Optional Service Bulletin

SB 808-34

Slotted hole modification of the elevator mass balance.

Figure 1: Slotted Hole Modification; nominal dimension of hole centre positions are put in boxes

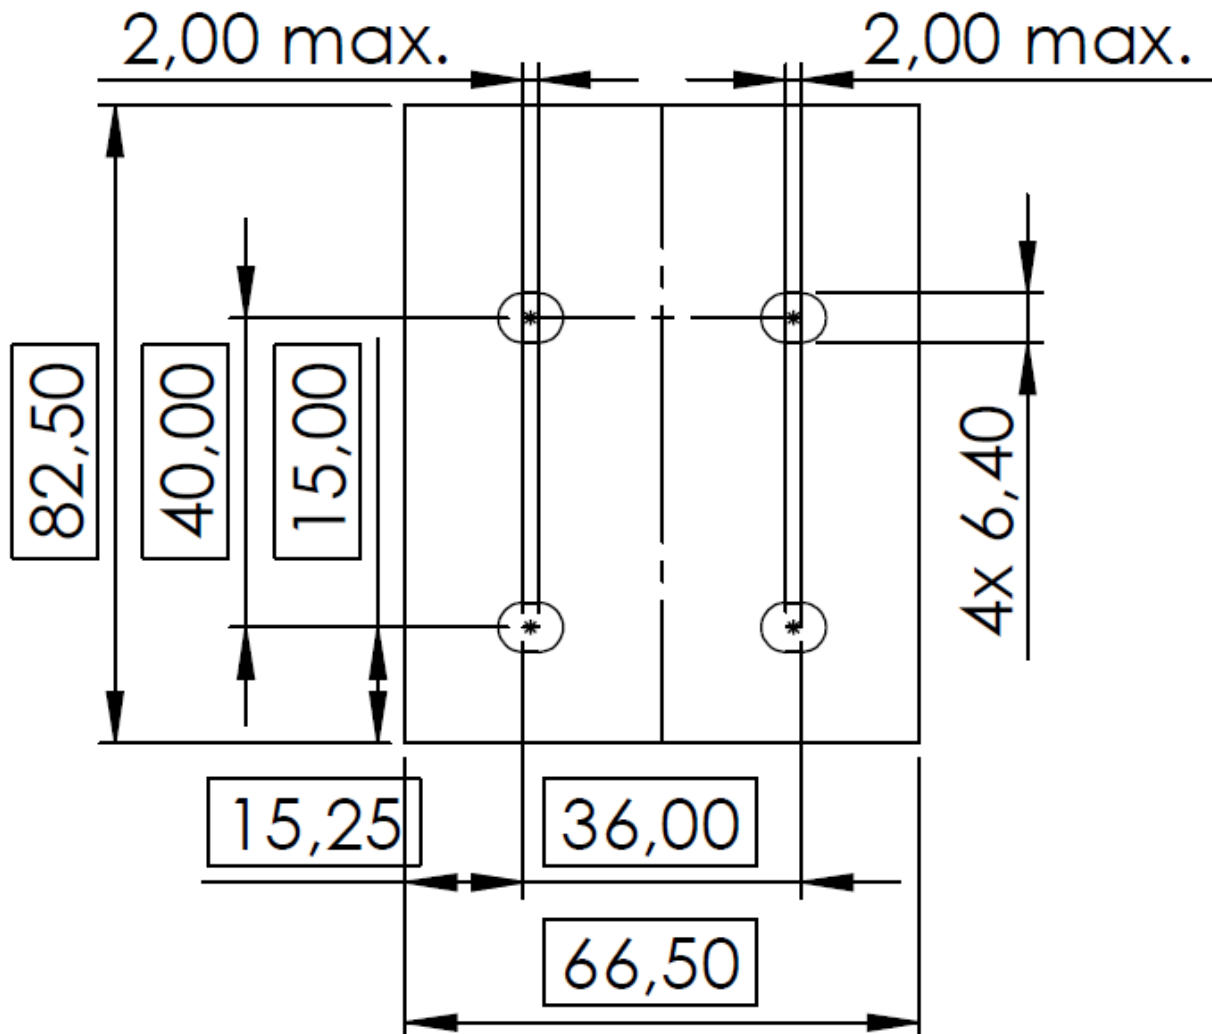
Modification of the elevator mass balance mounting holes. The holes are slotted symmetrically to the symmetry plane of the part until installation is possible. A maximum material removal of 2mm is allowed, see Figure 1. Material should only be removed, until the mounting of the part is possible. Thus, a measurement of the hole positions is obligatory.
